NOTICE OF DECISION
 612 CC St – Short Plat & Variance

Land Use Application No.:	WLD-2023-015
Applicant:	Nick Little 1760 Downriver Dr Woodland WA 98674 nlittle@chiltonlogging.com
Property Owner:	Tyrel Koistinen PO Box 1152 Woodland WA 98674 tykoist@gmail.com
Site Location:	612 CC St
Parcel:	50383
Zoning Designation:	Low Density Residential (LDR-6)
Date Application Received:	November 9, 2023
Date Application Complete:	December 19, 2023
Notice of Application:	January 8, 2024
Last Day of Comment Period:	January 31, 2024
Notice of Decision Issued:	February 12, 2024
DRC Decision:	Approved with Conditions

The applicants propose to create four new lots from the existing subject lot. A variance is requested for two of the lots to be 52.81 feet wide (less than the minimum required in the zone.)

**KT WEST, LLC
 SHORT SUBDIVISION**
 IN A PORTION OF LOT 27 IN THE
 "MRS. IDA E. PARENT'S ACRE TRACTS"
 (3-159), IN THE S. & M. BOZARTH DLC
 IN THE NW 1/4 NE 1/4 OF
 SECTION 24, T5N, R1W, W.M.
 CITY OF WOODLAND,
 COWLITZ COUNTY, WA.

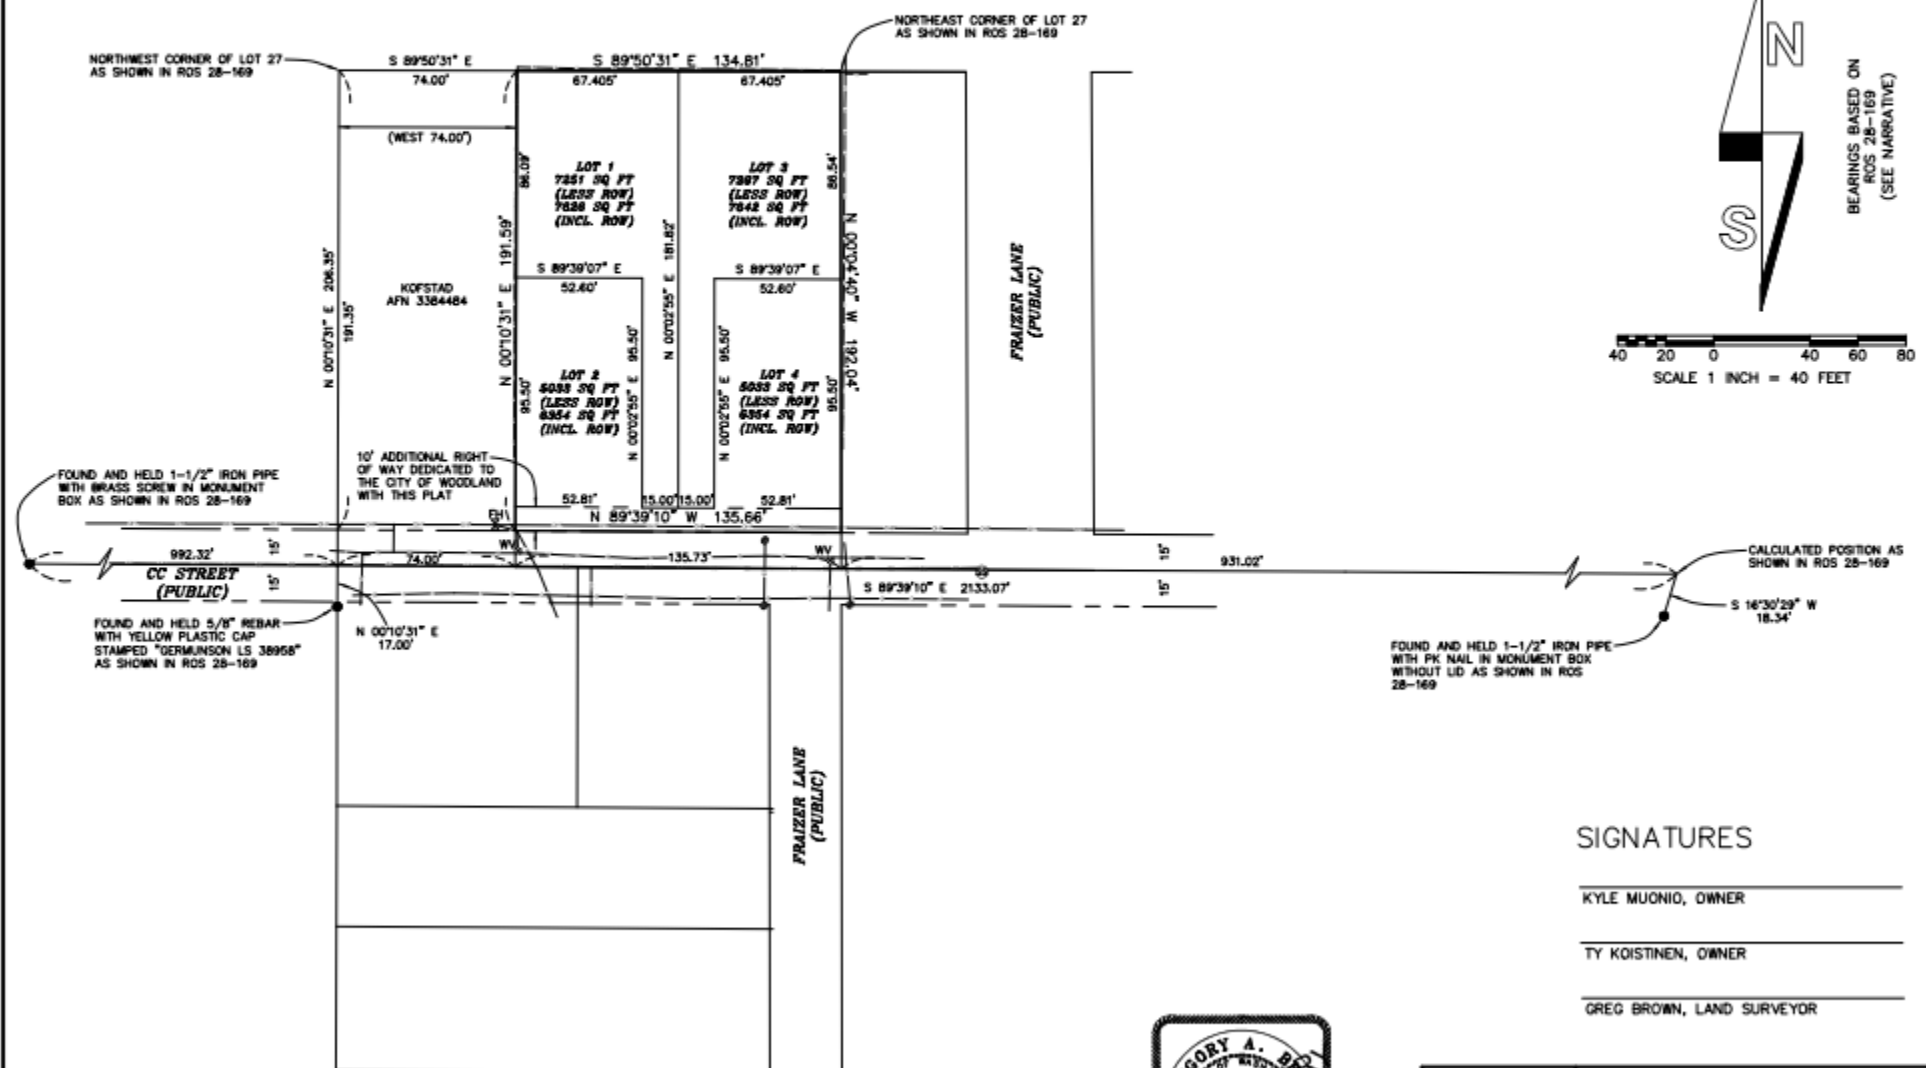
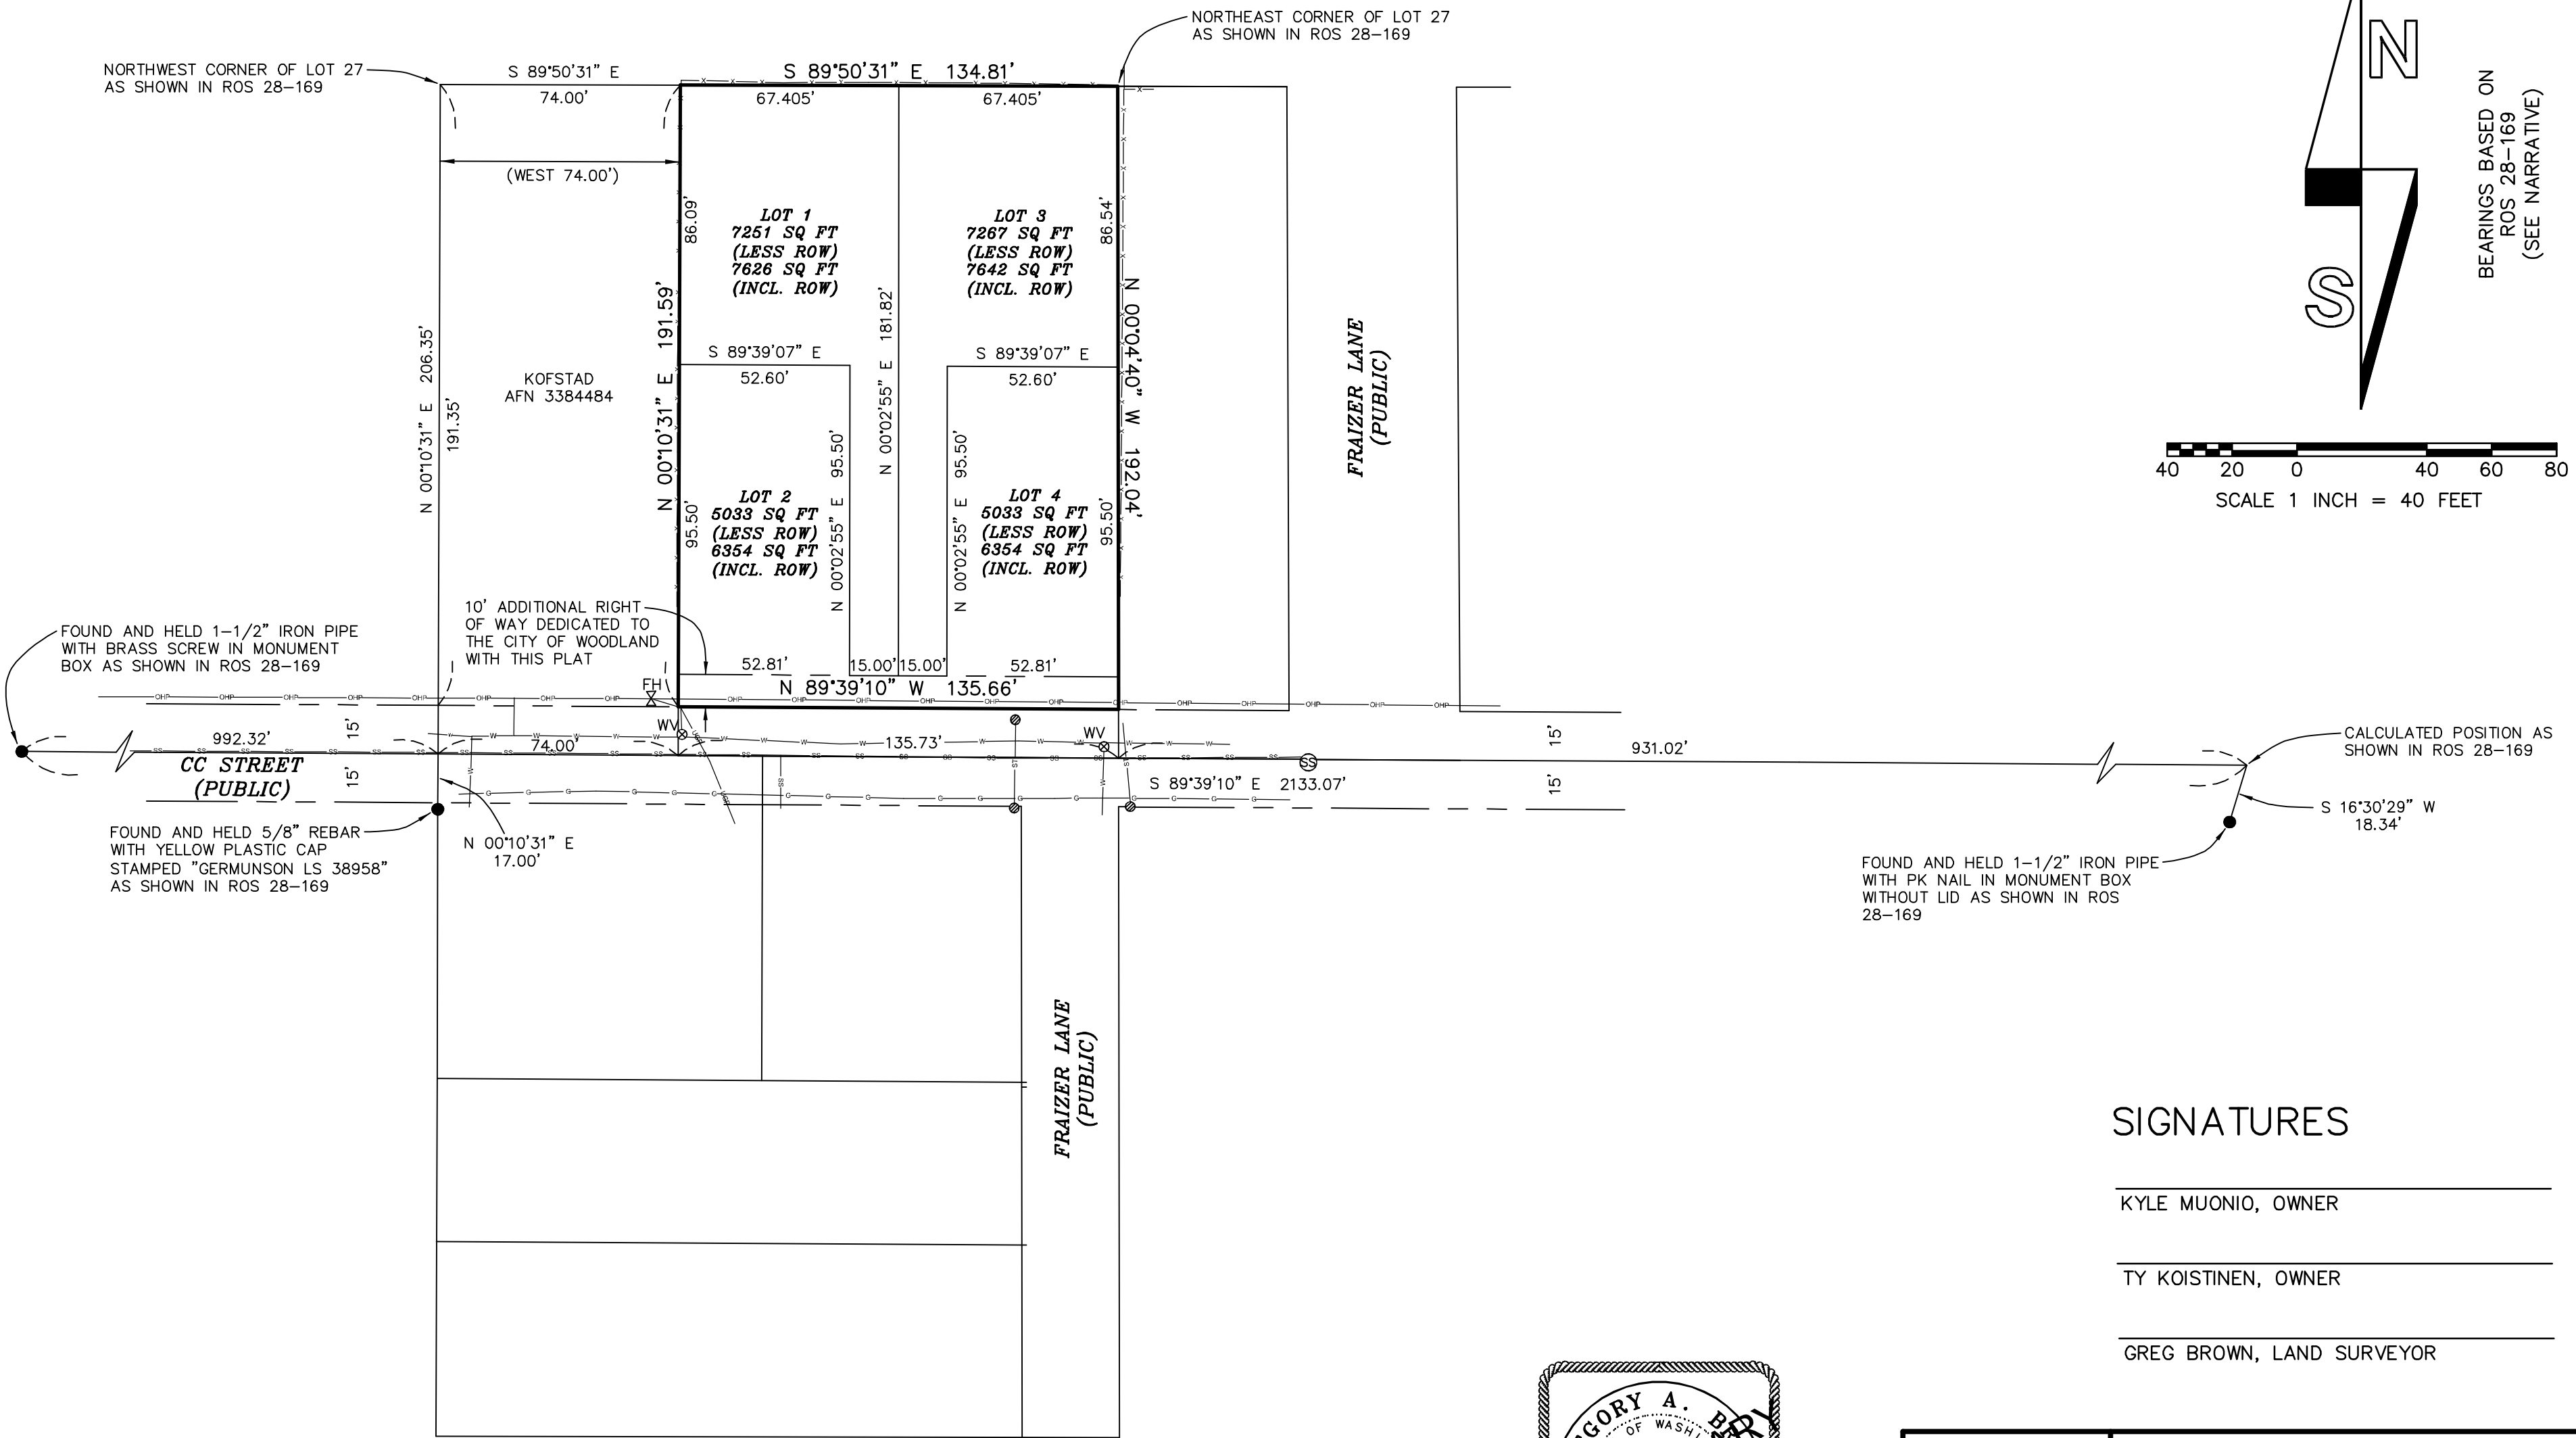
Finding 15: Per WMC 17.16.070.B, the minimum lot width for the zone is 60 feet. Lot 1 is proposed at 67.405 feet wide, Lot 2 is proposed at 67.405 feet wide, Lot 3 is proposed at 52.81 feet wide, and Lot 4 is proposed at 52.81 feet wide.

Conclusion: All proposed lots meet minimum size requirements. Two of the four lots do not meet minimum lot width requirements and the applicants have applied for a Variance permit.

Finding 17: The proposed variance for two of the four lots is an 11.98% variance to minimum lot width requirements.

Having resided here for a span of 12 years, I've observed a consistent issue at 612 CC Street concerning a depression that accumulates rainwater runoff. 612 CC Street collects water runoff from the streets during heavy rains. The rainwater flows through proposed Lot 3 and proposed Lot 4. This water can be over a foot deep.

18. Insufficient lot width shall not be used as justification to approve a future variance for setbacks.
19. The project must comply with all CCFR requirements (see attachment C).

- a. Access to the flag lots must be either 20' or 26' wide. To meet this requirement, no fence, vegetation, or any other obstruction may be placed between the driveways of the two flag lots to leave a combined 30' wide access.
